Design Changes

This information sheet describes significant revisions to the Nant y Moch Wind Farm proposal since it was first presented to the public at exhibitions in June 2009 in order to achieve the final layout presented at this Launch Event. Changes which occurred before and after the second round of exhibitions in June 2010 are presented separately. The proposal has been developed and adapted, drawing on the extensive range of surveys and assessments conducted for the Environmental Impact Assessment (EIA), as well as feedback from the public and key consultees. Changes are referenced to the map overleaf where relevant, which shows the June 2009 and final proposed wind turbine locations and final access track routing. The final layout represents the culmination of the EIA process and SSE-R's considered view of the best available wind farm development at the Nant y Moch site, given the known constraints and sensitivities. A more detailed plan of the final proposed layout can be found on the exhibition panels at this Launch Event.

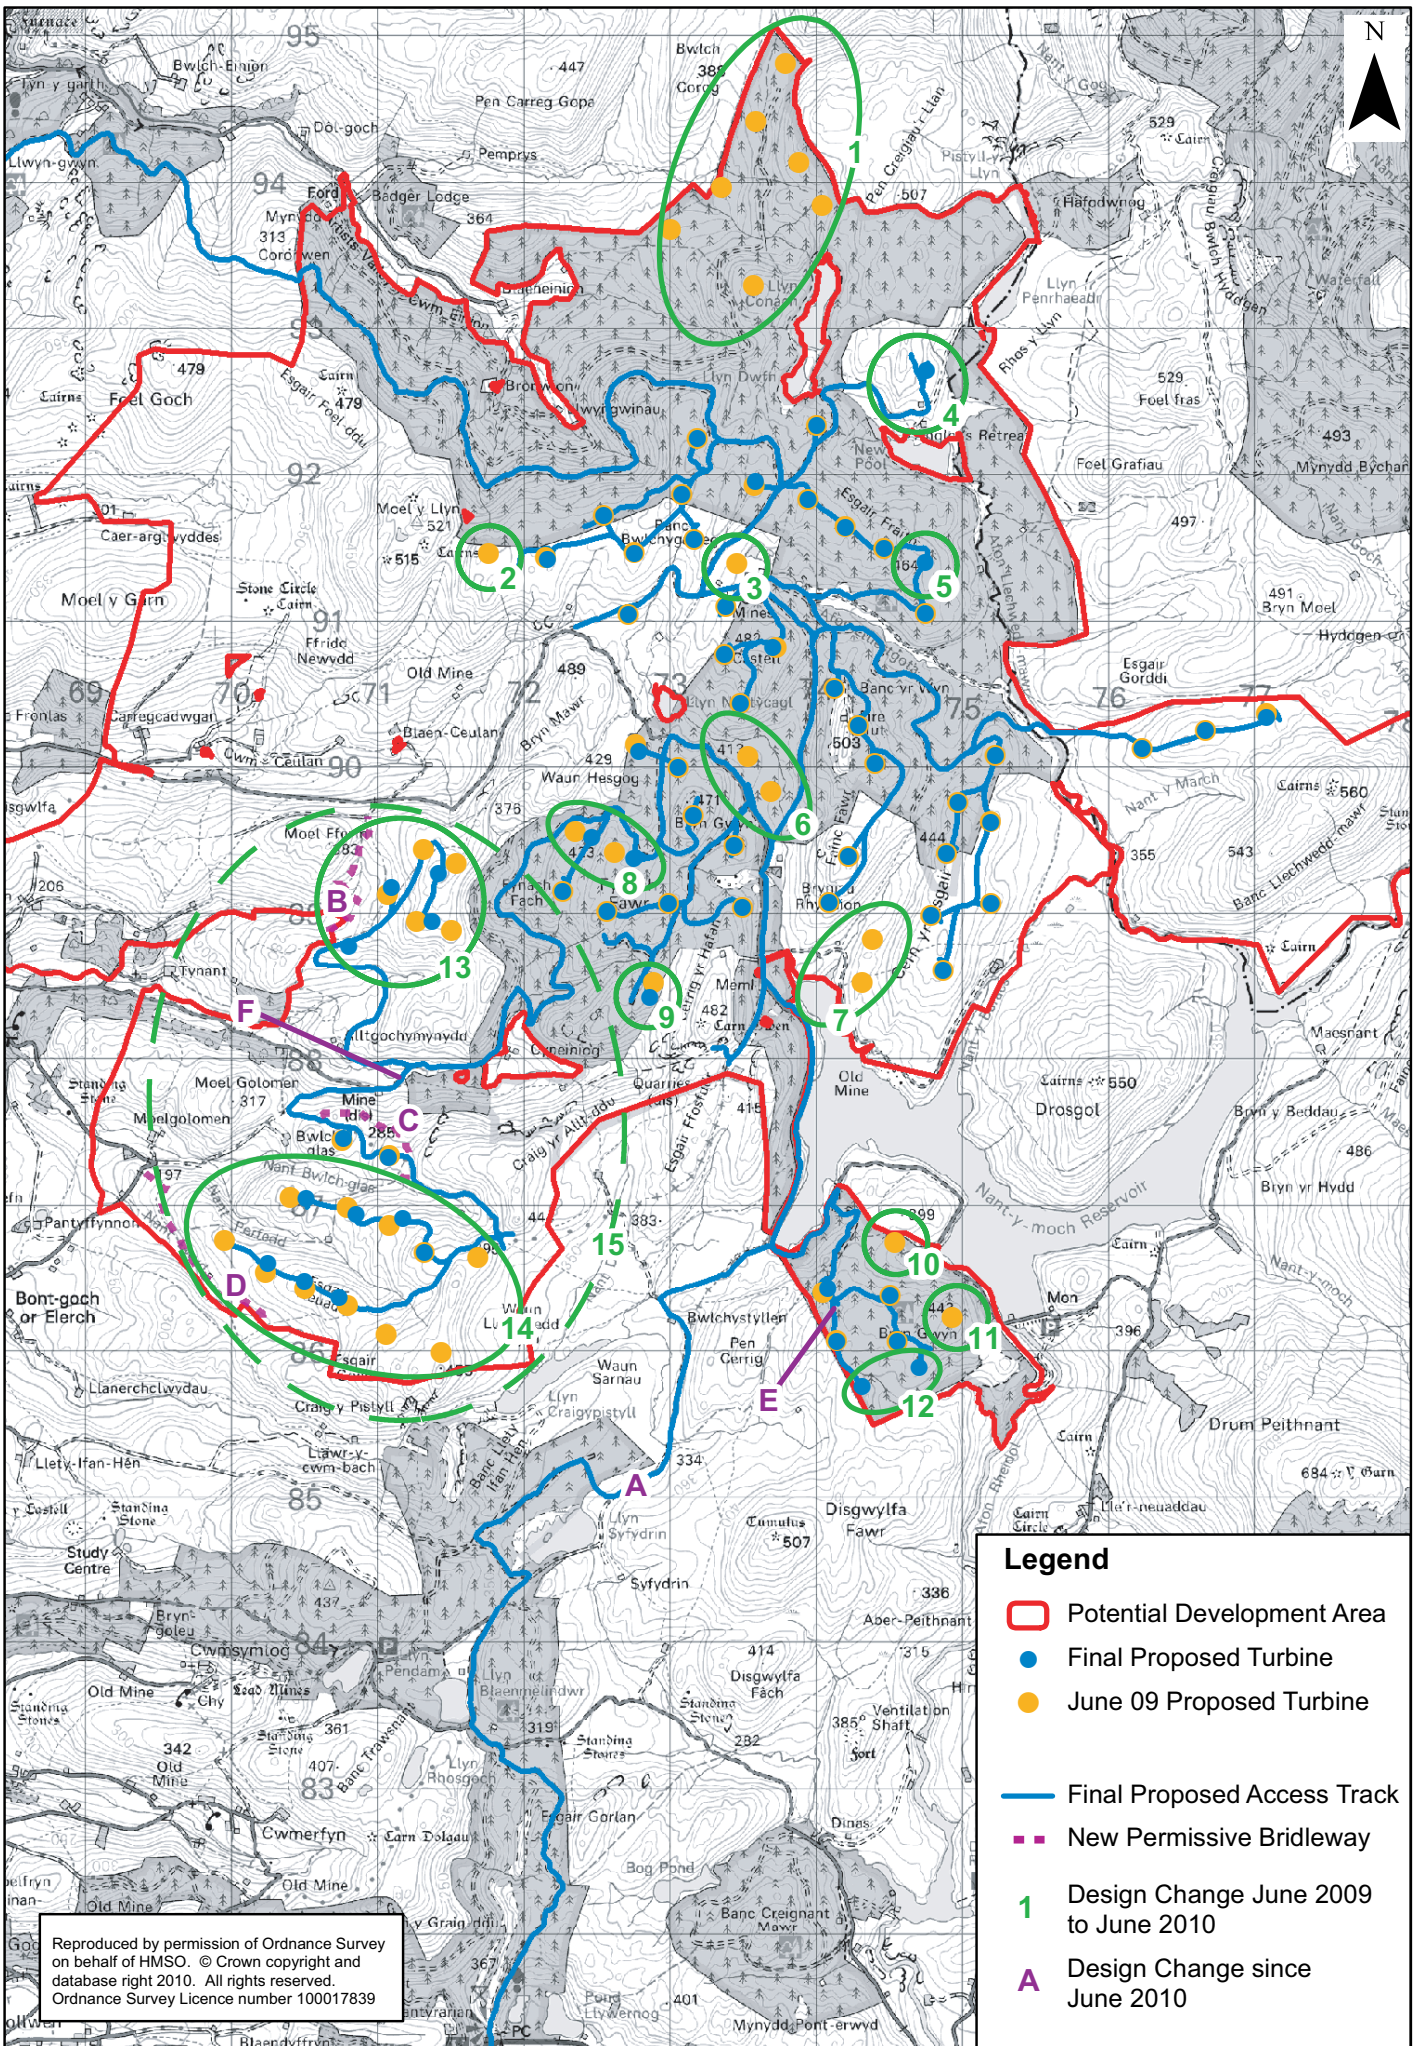
Map Ref	Design Change	Rationale
A	Confirmation of the proposed access route for Abnormal Load deliveries via Nant yr Arian	Access via Nant yr Arian was assessed as the preferred route for Abnormal Loads, considering a number of factors including the quality of the road network, potential disruption to local residents and road users and public and consultee feedback. The precise route used from Nant yr Arian has been selected to make best use of existing infrastructure and minimise impacts on the visitor centre and on peat and other environmental sensitivities.
N/A	Confirmation of use of infra-red aviation lighting	Following discussions with the Ministry of Defence, infra-red lighting of turbines, which is not visible to the naked eye, has been confirmed as an acceptable solution to ensure the safety of military aircraft using the area. SSE-R considers infra-red lighting to be the preferred approach as it avoids the visual impacts associated with visible lights.

B, C, D	Provision of new permissive bridleway routes	Provision for Public Right of Way users who wish to maintain a distance of the order of turbine tip height or greater to the turbines (see Public Rights of Way Briefing Sheet for further information)
E	Minor alteration to access track alignment	An opportunity to further minimise impacts on peat habitat was identified in final review of the proposed layout.
F	Revision of proposed access route to use the location of the existing crossing of the Afon Cyneiniog	Further consultation with the Local Highways Authority identified a preference to upgrade the existing river crossing rather than providing a new crossing as had been proposed.

Map Ref	Design Change	Rationale
1	Removal of the northernmost 7 wind turbines	These turbines were removed as a result of a review of the visual impact of the wind farm, which identified this area as performing poorly in visual terms and appearing as an 'outlier' to much of the rest of the proposed scheme. Removing these turbines significantly reduces the extent of the wind farm in views from locations to the north west including Borth, Aberdyfi and the Snowdonia National Park. This revision also reduces visual and noise impacts to isolated properties closer to the site, including at the head of Cwm Einion.
2	Removal of the westernmost wind turbine on Banc Bwlchgarreg	The originally proposed location for this turbine proved to be an area with sensitive peat ecology. Whilst it would have been possible to re-site it around this constraint, a review of the visual impact of the wind farm also identified it as one of the worse performing locations and its removal helped reduce noise impacts to isolated properties at the head of Cwm Einion.

3	Removal of a wind turbine close to the Esgair Hir mine	This turbine was removed due to hydrological and peat sensitivities. This also had the added benefit of reducing visual clutter in the centre of the site.
4	Addition of a new wind turbine north of New Pool	Further survey work identified this additional viable location.
5	Addition of a new wind turbine at the eastern end of Esgair Fraith	Further survey work identified this additional viable location.
6	Removal of two wind turbines in the centre of the site close to Nant Rhuddlan	Analysis and modelling of wind flows on the site indicated that this location was not suitable due to very high wind shear (variation of wind speed with height).
7	Removal of two wind turbines immediately north of Nant y Moch Reservoir	Analysis and modelling of wind flows on the site indicated that one of these locations was not suitable due to very high wind shear (variation of wind speed with height). Archaeological sensitivities and historic mine workings along the only available access route and limited but relatively deep peat at the turbines lead to a decision to remove both locations.

8	Relocation of two wind turbines north of Fynach Fawr	The westernmost of this pair of turbines was relocated to a position where the turbine base and harstandings would be easier to construct, thereby minimising cutting works which can be visually intrusive. The other turbine was then moved to maintain the required separation between the turbines.
9	Relocation of one wind turbine at Moel Cyneiniog	This turbine was moved south to avoid an area of relatively deep peat identified as sensitive through peat probing and ecological surveys.
10	Removal of one wind turbine at the north of Bryn Gwyn, south of Nant y Moch Reservoir	Analysis and modelling of wind flows on the site indicated that these locations were not suitable due to very high wind shear (variation of wind speed with height).
11	Removal of one wind turbine at the east of Bryn Gwyn, south of Nant y Moch Reservoir	This turbine was removed as a result of a review of the visual impact of the wind farm, which identified it as particularly dominant in views from the car park adjacent to the reservoir.

Map Ref	Design Change	Rationale
12	Addition of two new wind turbines at the south of Bryn Gwyn	Further survey work identified these additional viable locations, which were not subject to the wind shear issues or level of visual sensitivity note above.
13	Revision of wind turbine locations on private land to the east of Moel Fferm	Turbine locations in this area were extensively revised including reducing the number of turbines from 5 to 4. Primary reasons for the revision were improving separation to public rights of way, achieving locations where the turbine base and harstandings would be easier to construct and reducing noise impacts to properties at the head of Cwm Ceulan to the north.
14	Revision of wind turbine locations on private land around Esgair Neuadd and Pen Craigyppistyll	Turbine locations in this area were extensively revised including reducing the number of turbines from 11 to 7. Primary reasons for the revision were improving visual performance following a review of the visual impact of the wind farm, improving separation to public rights of way, and in the case of the easternmost turbines in this group, also reducing impacts on the setting of scheduled ancient monuments. The design revision has helped reduce visual impact to a wide range of locations and specifically visual clutter and dominance when viewed from Bont Goch.

n/a	1.5m increase in the proposed maximum tip height of the turbines (from 145 to 146.5m)	Further wind resource analysis and discussions with turbine manufacturers identified that this slight increase in the maximum height was required in order to accommodate a selection of the most appropriate turbines models for this site. Turbines from established manufacturers including Vestas, Siemens and RePower are under consideration. SSE will determine the actual turbines to be used closer to the time of build, if planning permission is received. They will need to fit within the maximum dimensions proposed.
15	Reduction of the maximum tip height of turbines in the south west of the site, outside the the forestry land, to 126.5m (80m hub height)	The primary reason for the use of 100m tower heights on this site is to reduce the effect on the turbines of turbulence and wind shear caused by the trees. For turbines in the south west of the site, where there is no forestry affecting the prevailing south-westerly winds, turbulence and wind shear are less of a concern and shorter towers are an option. A review of the visual impact of the wind farm concluded that reducing turbine heights in this area would significantly improve the visual performance of the overall scheme, especially in terms of views from Bont Goch, and from locations to the north west including Borth, Aberdyfi and the Snowdonia Nation Park.

In addition to the revisions to turbine locations described above, changes were made to track routing and elements of other site infrastructure as a result of peat probing and other surveys. Most significant of these changes was the relocation of the substation to a position adjacent to the public road near the centre of the site. The previously proposed substation location at Bryn Glas was found to be on relatively deep peat.

The new location is one of the few other areas within the site that offers sufficiently level ground for the substation. As the design has developed, proposed locations were also confirmed for various other elements of the development, including permanent met masts, borrow pits and temporary construction compounds, laydown space and a concrete batching plant.
